2022/1129

Description: Erection of 1no dormer bungalow and associated works

Site Address: Land adjacent 86C Burton Road, Barnsley, S71 2AA

Elevations

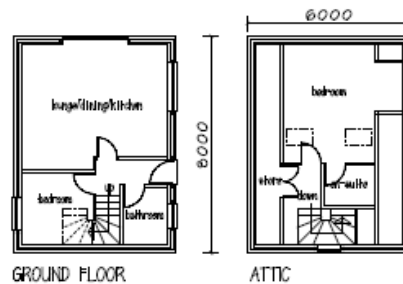
The design of the dwelling in part is dictated to by the size of the site and the proximity of the neighbouring properties. To avoid overlooking of the terraced dwellings to the South, the elevation facing the access road is predominantly blank with 1 small window at first floor level. As such the dwelling turns its back on the streetscene and offers little in terms of interaction or visual amenity.

The dwelling also has relatively high eaves with blank brick work above the window headers and below the eaves. This, combined with the roof pitch and dormers, gives a top heavy appearance and is in contrast with the neighbouring dormer bungalow which has its eaves closer to its window headers.

Given the proximity of the dwelling to the access road, the narrow width of the plot and the position of the driveway there is limited opportunity for a front garden and soft landscaping. As such, the dwelling would be visually dominant on the access road and have a negative impact on the visual amenity of the streetscene, contrary to Local Plan Policy D1.
